FORD E40D "UPDATE HANDBOOK"

INTRODUCTION FORD E4OD "UPDATE HANDBOOK"

**FORD E40D
VALVE BODY, SPACER PLATE, SPACER PLATE GASKETS,
CHECKBALL LOCATIONS, AND CASE CHANGES,
FOR THE 1996 MODEL YEAR**

Figure 1

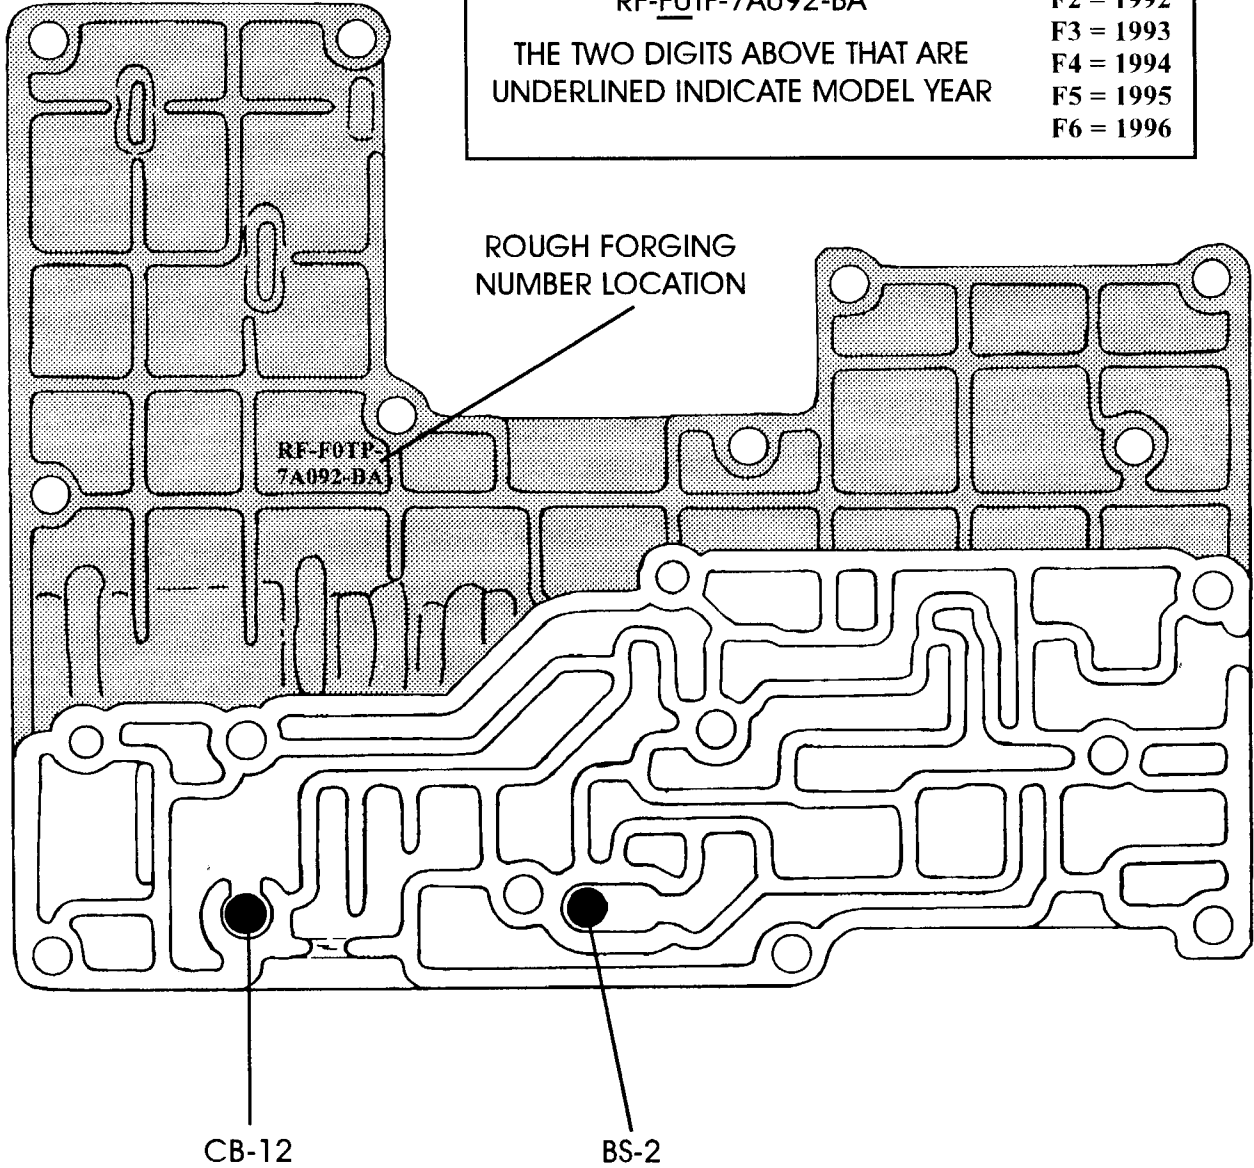
(1) **VALVE BODY CHECKBALL LOCATIONS** - Have remained the same for 1989 thru 1995 model years, with **TWO** 5/16" rubber checkballs, and their locations are shown in Figure 1. Beginning in the 1996 model year there are **FIVE** checkballs in the main valve body and their locations are shown in Figure 2. Notice that there are two 5/16" rubber balls and three 1/4" rubber balls. The 1/4" rubber balls are green in color (See Figure 2).

Figure 2

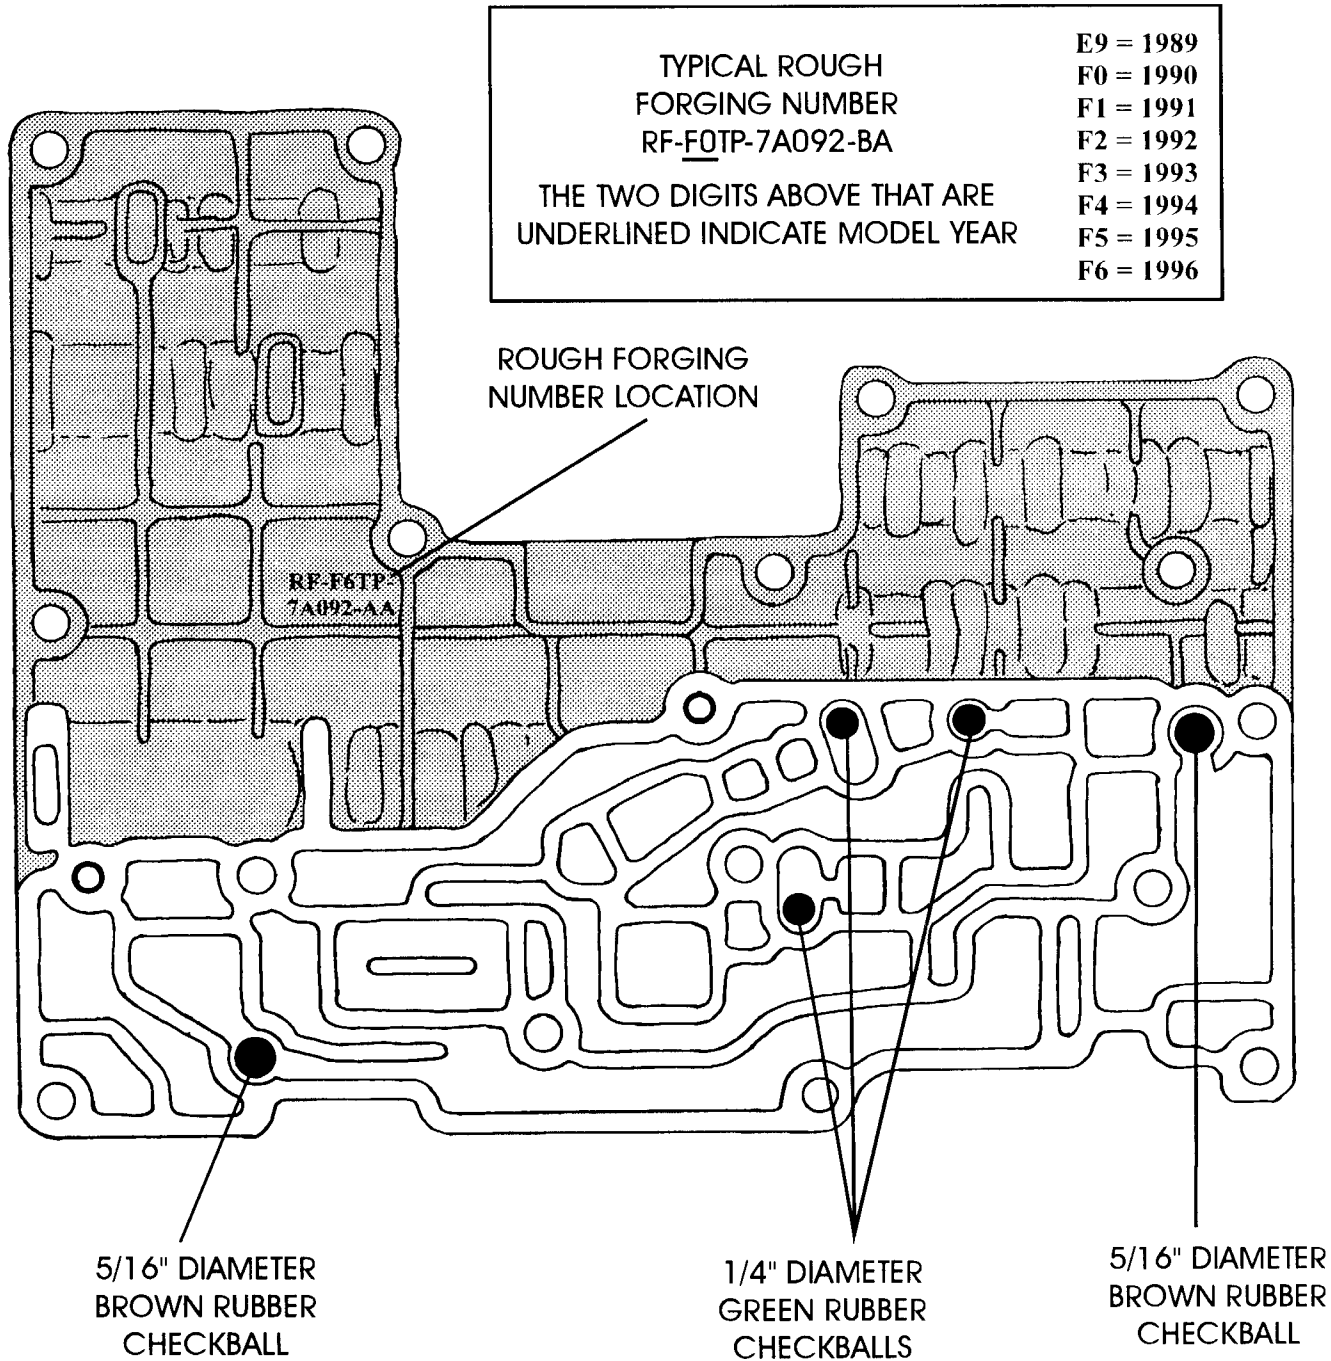
1996 VALVE BODY CHECKBALL LOCATIONS
REQUIRES THREE 1/4" RUBBER BALLS,
AND TWO 5/16" RUBBER BALLS

Figure 3
AUTOMATIC TRANSMISSION SERVICE GROUP

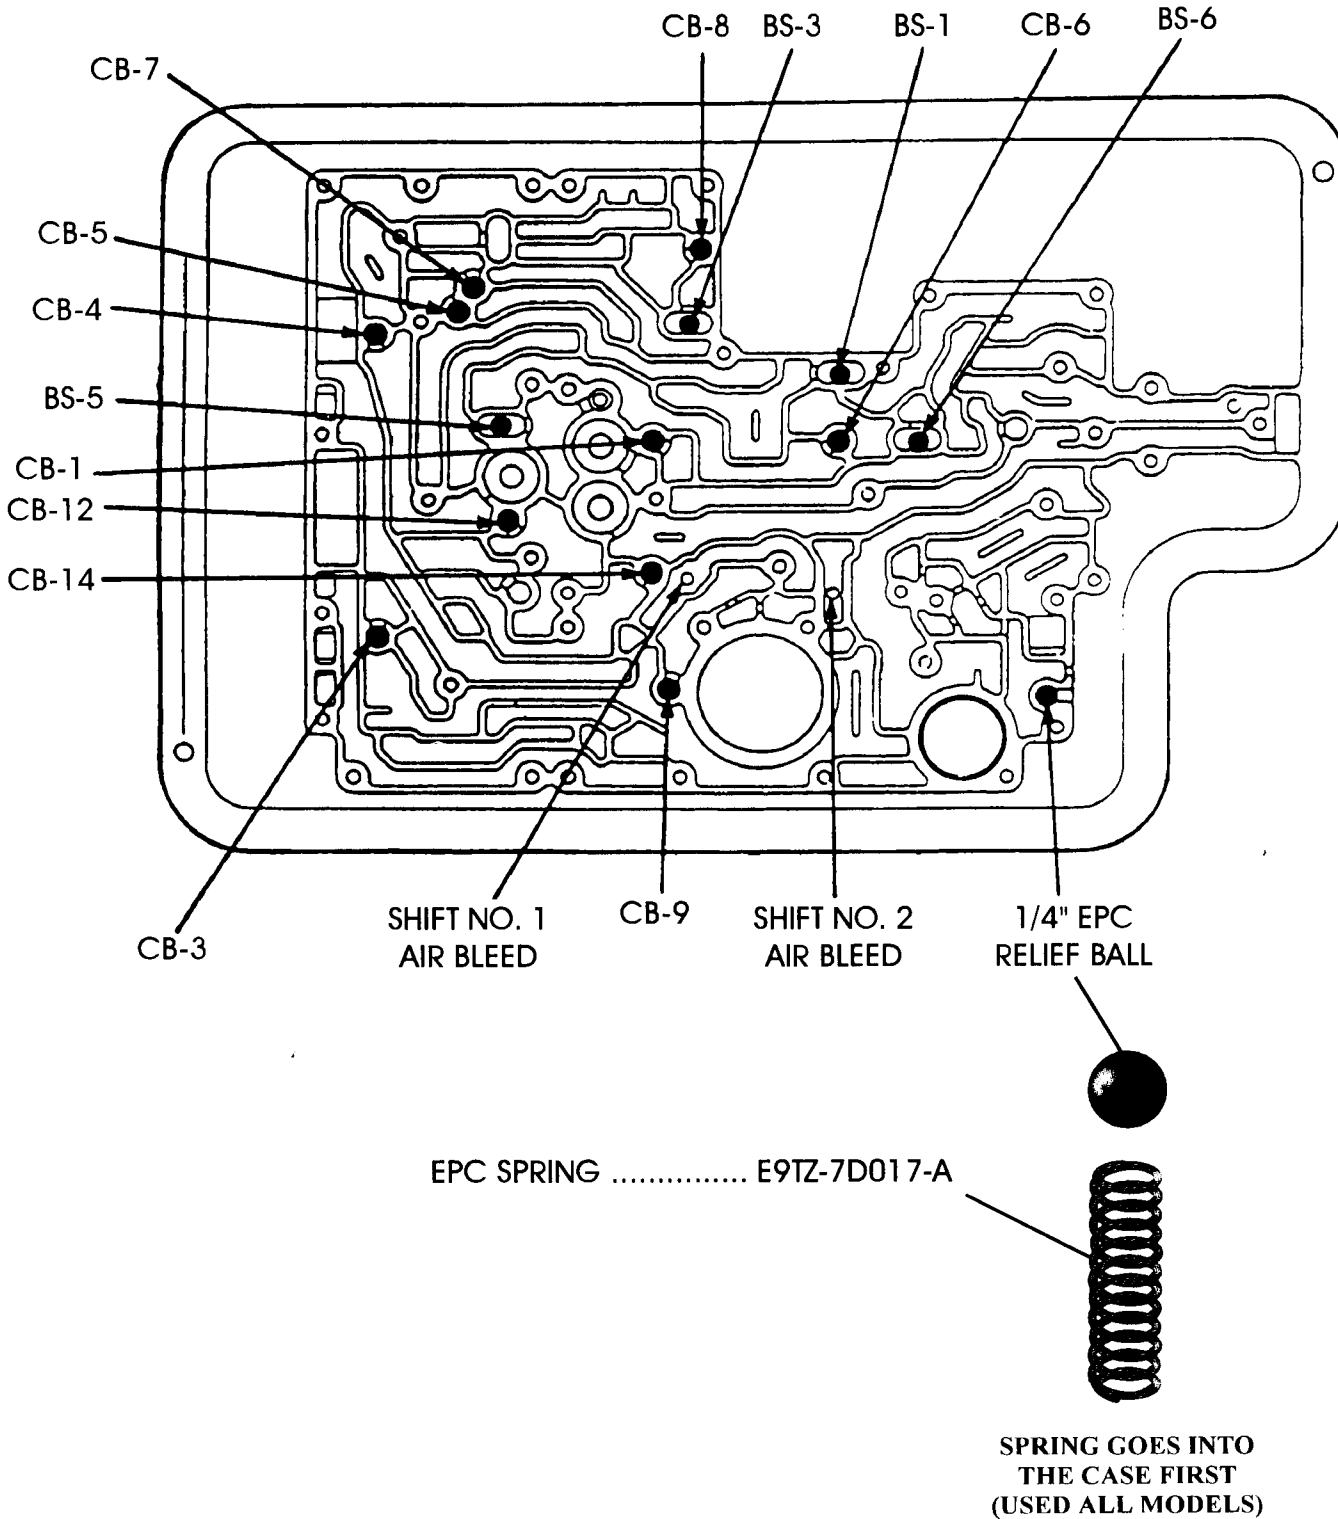
Early 1989 Models - Requires **Fourteen** 5/16" checkballs in the case, in the locations shown in Figure 3, and uses a 1/4" steel ball for the EPC blow-off, and location shown in Figure 3.

Figure 4

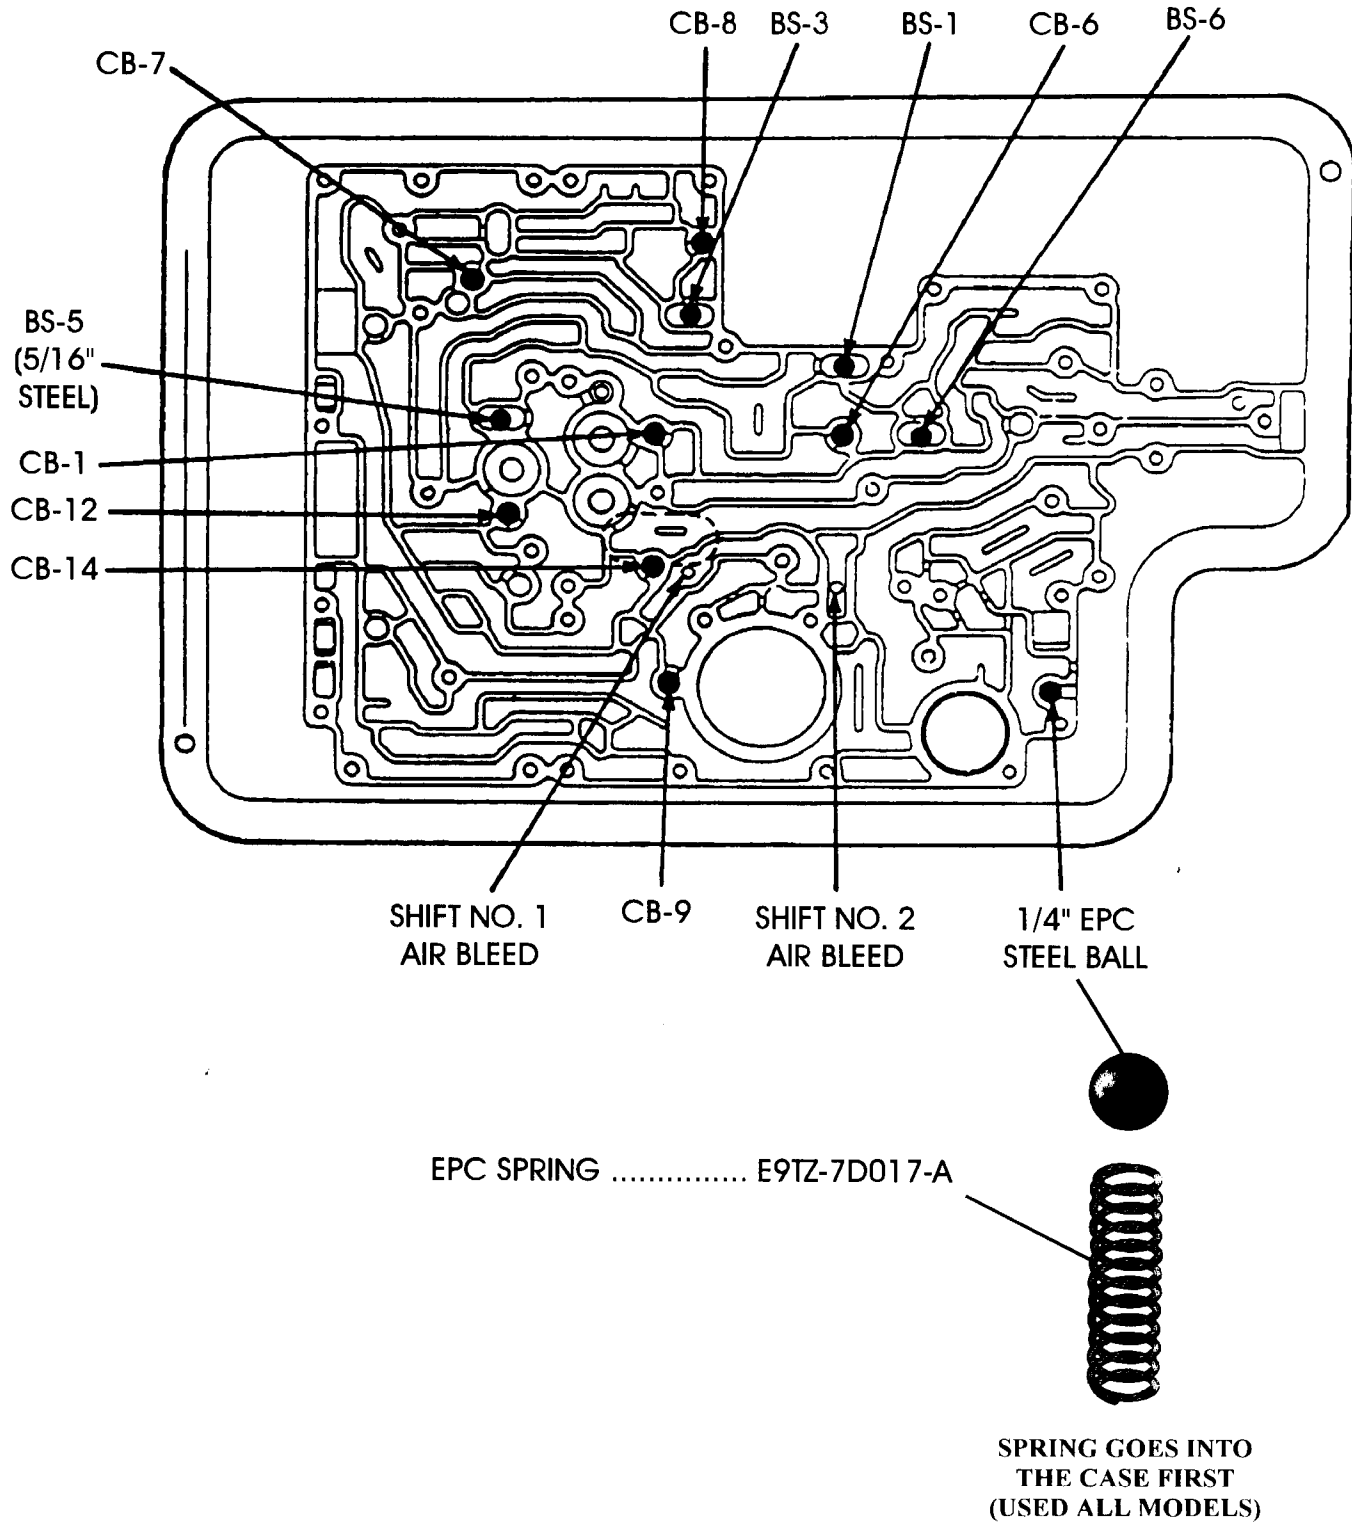
Late 1989 Models - Requires **Ten** 5/16" rubber checkballs, and **One** 5/16" diameter steel checkball, for a total of **Eleven**, in the locations shown in Figure 4, and uses a 1/4" steel ball for the EPC blow-off, and the location is shown in Figure 4.

Figure 5

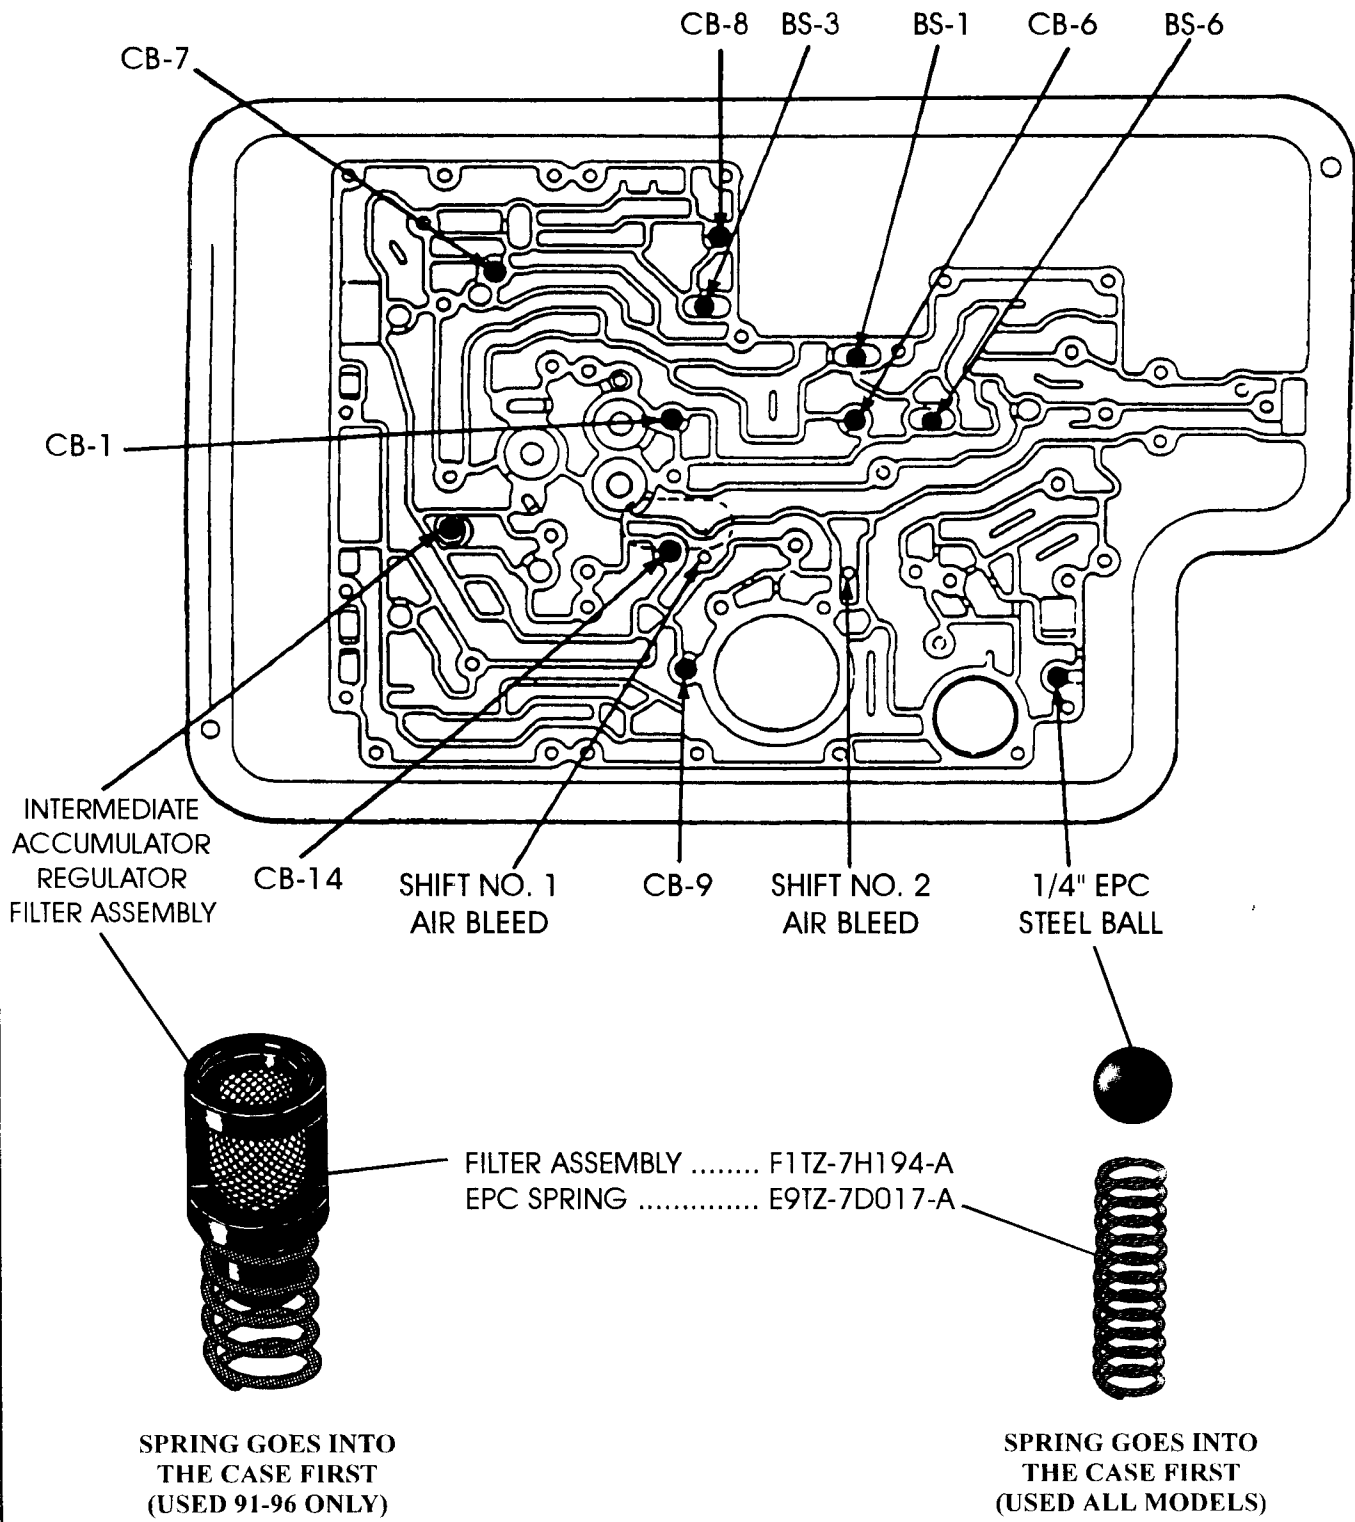
All 1990-1995 Models - Requires **Nine** 5/16" rubber checkballs in the case, in the locations shown in Figure 5, and uses a 1/4" steel ball for the EPC blow-off, and the location is shown in Figure 5. Beginning in 1991 there is an added Intermediate Accumulator Regulator Filter Assembly, and the location in the case is shown in Figure 5.
